Design Update: Hebrides People Visitor Centre

Prepared By Studio Hebrides Architecture

Date 06.08.24

Revision A

Existing Site

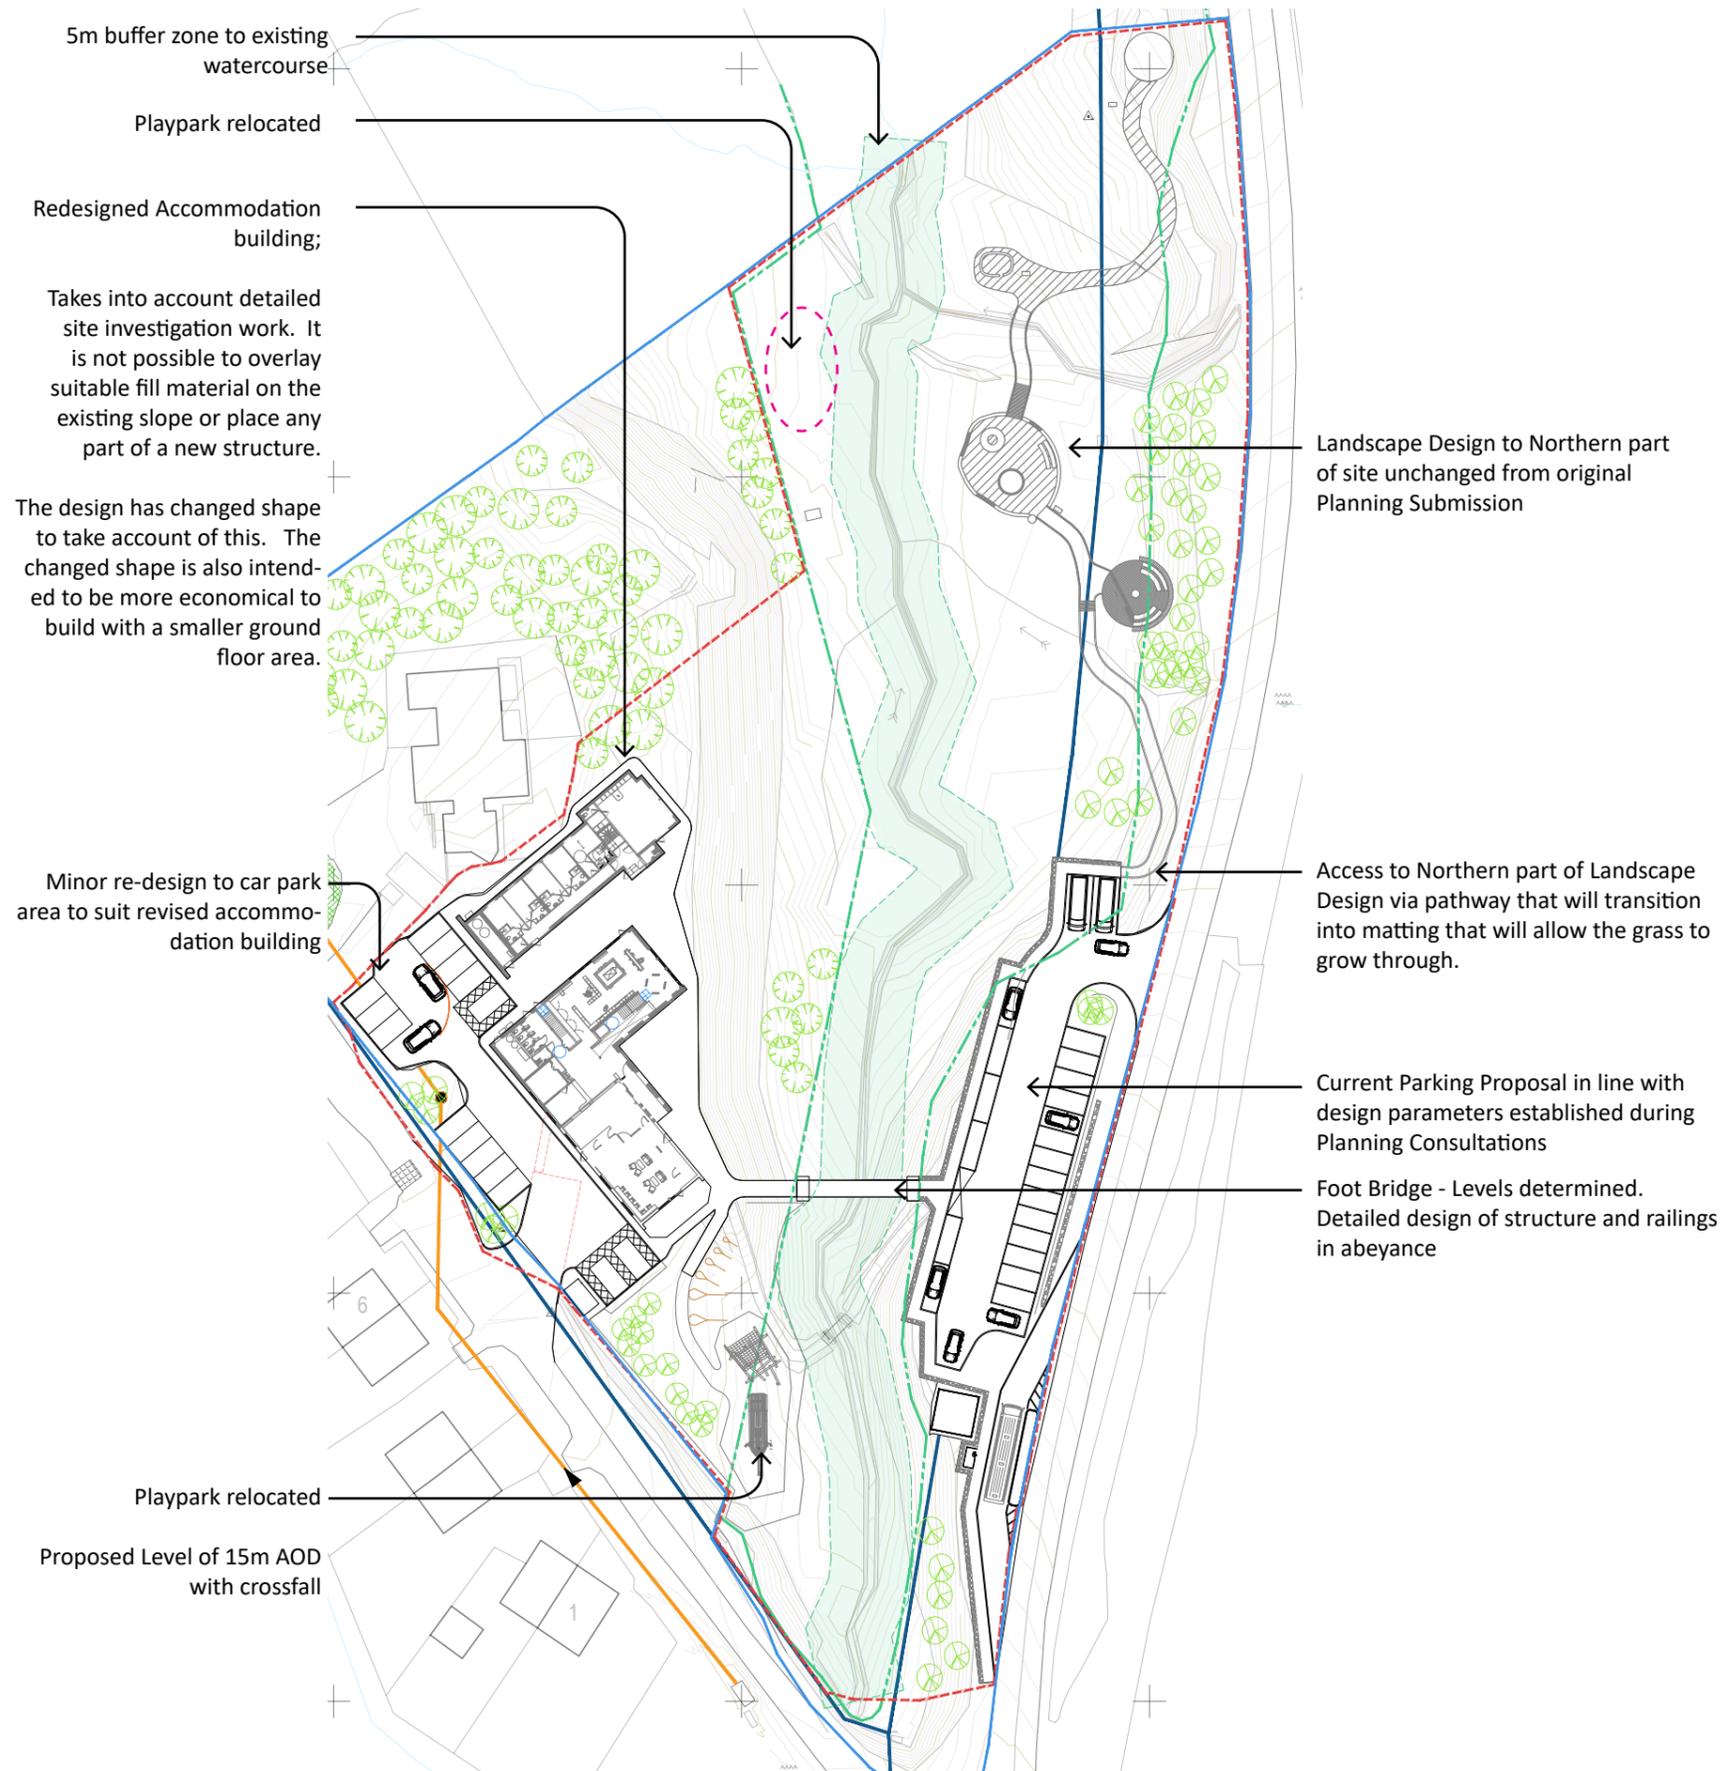
The design drawings have been updated to clarify which features are identified for removal.

Minimum no. of trees identified for removal to facilitate construction of accommodation building

All vegetation removed where affected by new building and parking footprint

Existing (unused) septic tank removed

Oil tanks removed - noted risk of ground contamination

Non Native species selectively removed. Native species retained in this area.

Full extent of existing stone walls to be removed to accommodate proposed new parking area.

Stone to be retained for re-use.

Sections of the existing foot path may be retained to facilitate maintenance access

Existing bus shelter removed

Non Native Sitka Spruce to be removed to facilitate new access and parking to be constructed and planting of native species

3. Engineer's Design and Car Parking

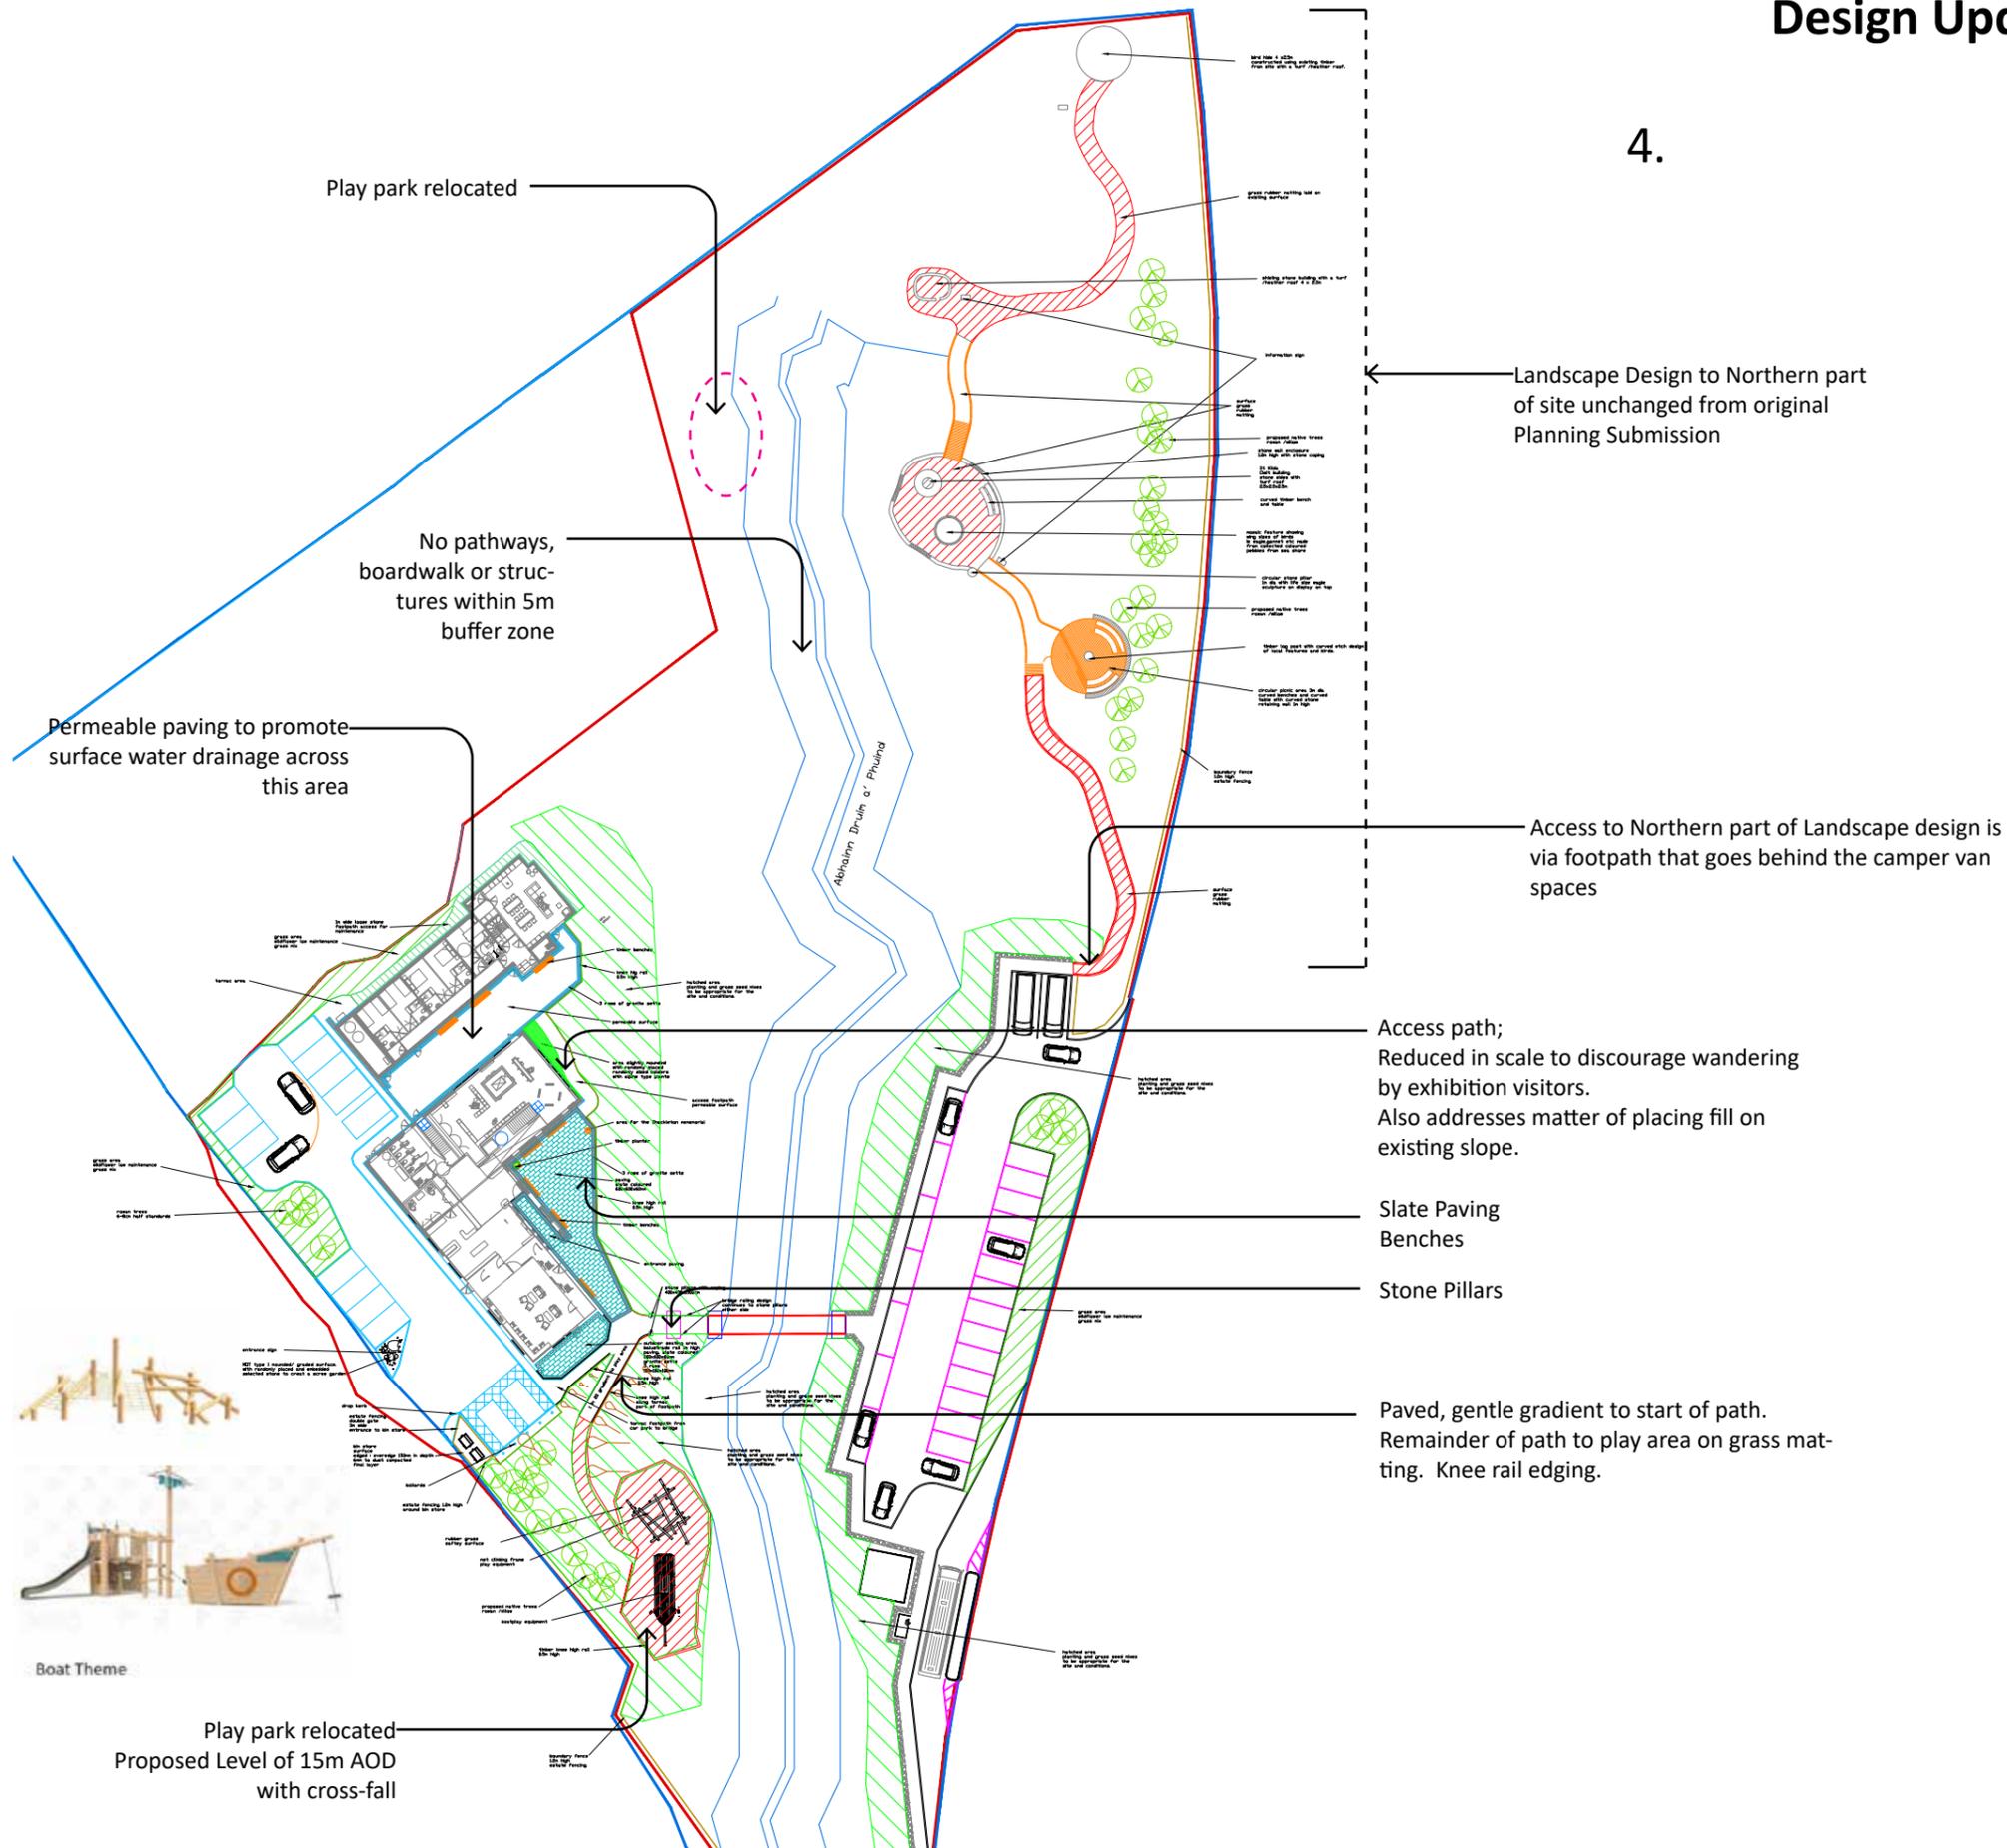
The parking provision and all pathways and landscape levels have been determined by the engineer. This update includes relocating parking space that was in front of the bridge access and introducing a new stone wall along the roadside. The proposed levels are shown blue on the drawing. There is no regrading work within the 5m watercourse buffer zone

Access to Northern part of Landscape design is via footpath that goes behind the camper van spaces

Accessible Route; 1.2m minimum width maintained along route

Accessible Route; 1.2m minimum width maintained along route

New masonry wall outside of visibility splay

Level at play park entrance to be +15m AOD Intention is to avoid regrading work within SSSI area and 5m buffer zone

Ground Floor Plan Originally Submitted

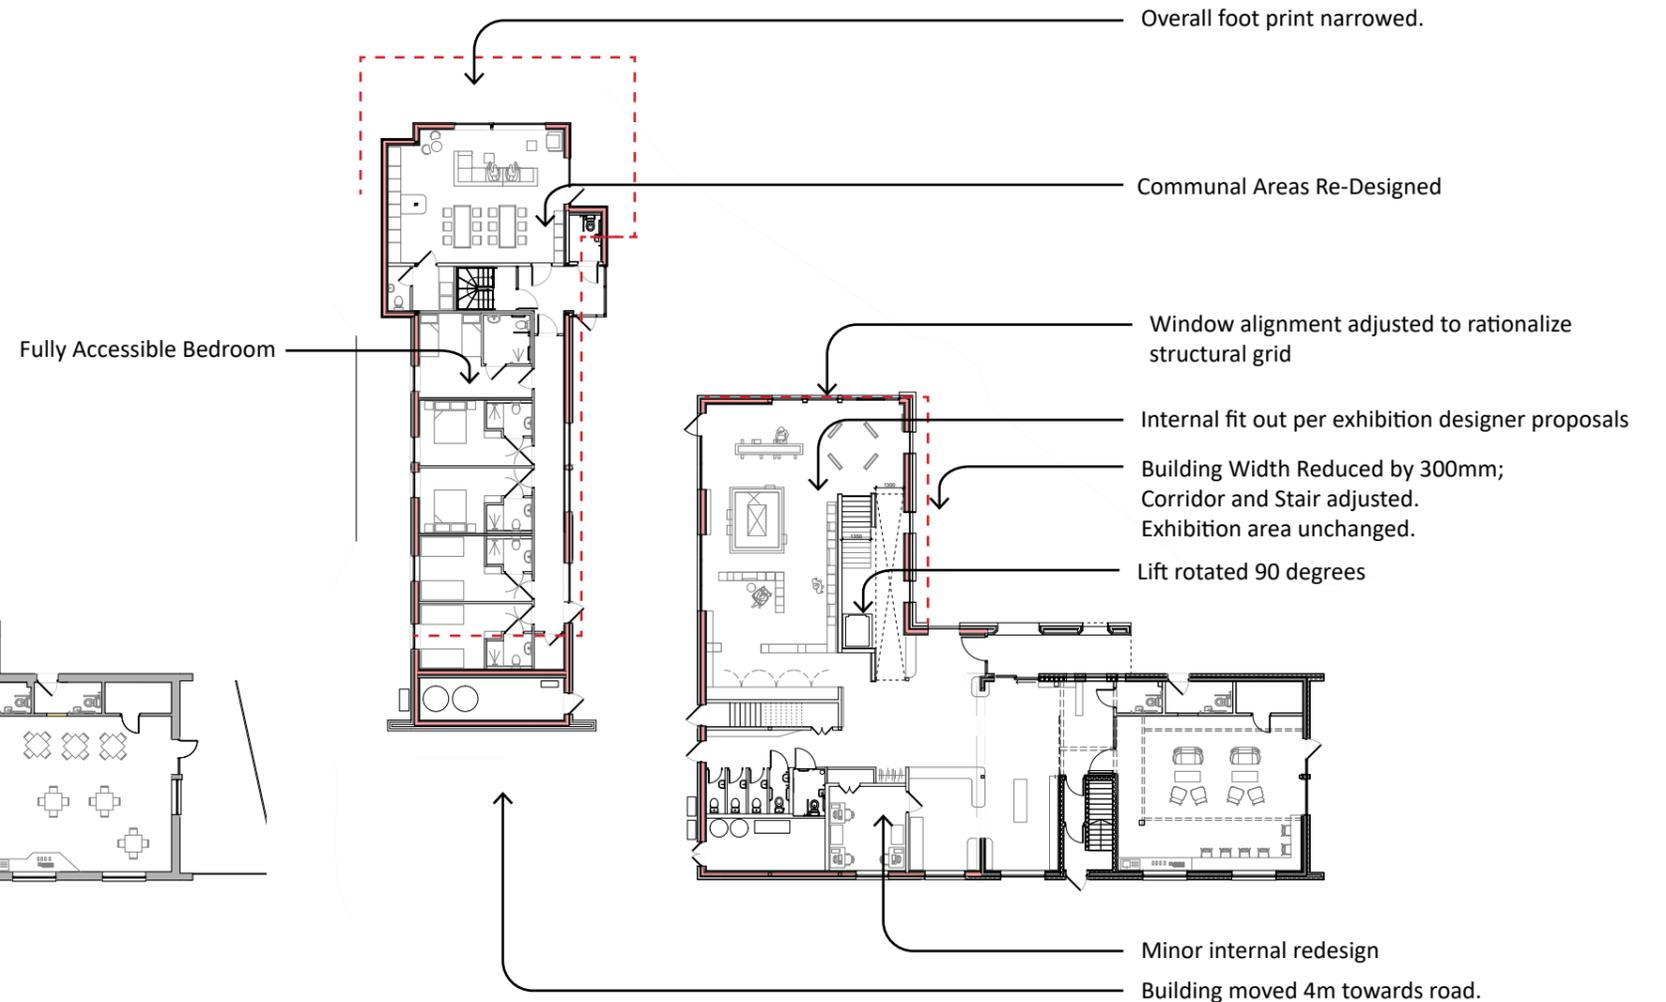
The Building Design has been updated in orders to achieve the following;

- Efficiency improvements
 - Reduction in overall floor area- approximately 35sqm across the scheme
 - Improve circulation and avoid- all escape routes now exit on the same side of the building

- Reduce overall structural widths ;
 - Shape of accommodation building is easier to construct and should require less long/larger section material
- Address Detailed Ground Investigation results;

- Accommodation Building moved and lowered, building made narrower which addresses updated ground investigation information that overlaying material to build up part of the slope is best avoided

- Visual massing
 - Remove original long and wide perpendicular “lean-to” roof on accommodation building and replace with more domestic scaled “gable end” design

- Visual cohesion
 - Gable end of accommodation building now in the same style as main extension building.
 - Integration of fully accessible sanitary facilities

- Further minor internal re-plan to gain efficiencies in floor space.

Elevations as currently proposed.

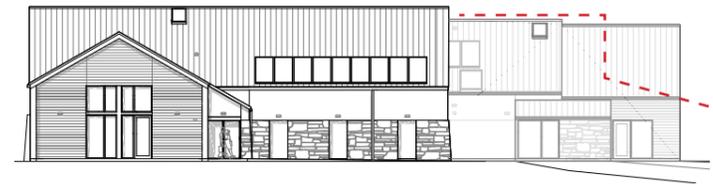
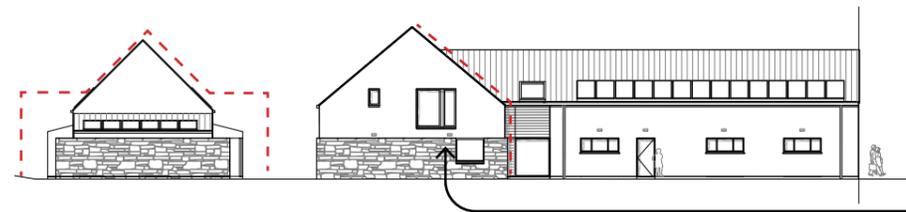
Window alignment adjusted to rationalize structural grid

Window alignment adjusted to rationalize structural grid.
Height of stone cladding adjusted.
